Access Compliance Report

Public Rights-of-Way

Intersection ID: 48572	Main Street: MATLEA_CT	Cross Street: SALAMANDER_RUN_LN	Location: NE
ADA ID: F79ED531ADDE	Ramp Type: PerpDiag	Initial Pass/Fail: Fail	Overall Compliance: No
		Severity Score: 10

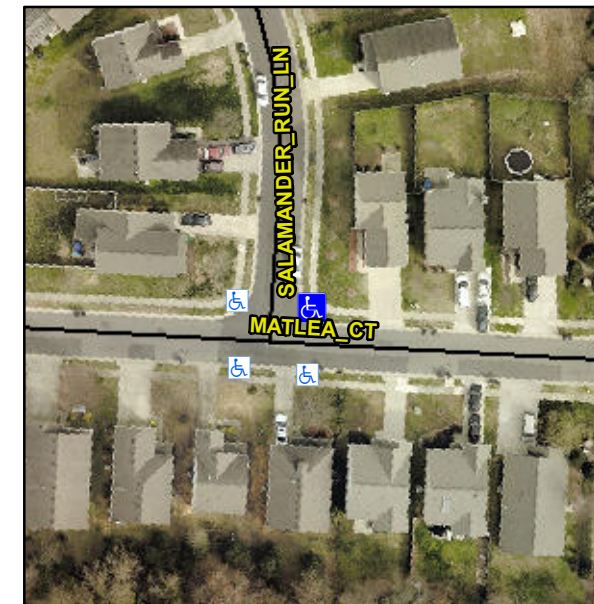
Not Found, R304.5.1, R304.5.3

Compliance	Description	Data	Compliance	Description	Data
N/A	Ramp Length (in)	49.0	Yes	Ramp Slope (%)	5.5
No	Ramp Width (in)	47.5	No	Ramp XSlope (%)	4.7
N/A	Flare Type LT	N/A	N/A	Flare Type RT	N/A
N/A	Flare Slope LT (%)	N/A	N/A	Flare Slope RT (%)	N/A
N/A	Flare Traversable LT?	N/A	N/A	Flare Traversable RT?	N/A
N/A	Landing Length (in)	N/A	N/A	DWS Provided?	N/A
N/A	Landing Width (in)	N/A	N/A	DWS Contrast?	N/A
N/A	Landing Slope (%)	N/A	N/A	DWS Length (in)	N/A
N/A	Landing X Slope (%)	N/A	N/A	DWS Full Width?	N/A
N/A	Landing Curb? (Y/N)	N/A	N/A	DWS Offset (in)	N/A
N/A	Shared Landing?	N/A			
N/A	Gutter Ponding?	N/A	N/A	Gutter Slope (%)	N/A
N/A	Gutter Lip Ht (in)	N/A	N/A	Gutter X Slope (%)	N/A
N/A	Painted X Walk1?	No	N/A	Painted X Walk2?	No
	X Walk 1 Direction	To W		X Walk 2 Direction	To S
N/A	X Walk 1 Width (in)	N/A	N/A	X Walk 2 Width (in)	N/A
	X Walk 1 Slope (%)	1.1		X Walk 2 Slope (%)	5.0
	X Walk 1 X Slope (%)	3.5		X Walk 2 X Slope (%)	1.1

Remove & Replace Curb Ramp With Two New Directional Ramps or Equivalent.
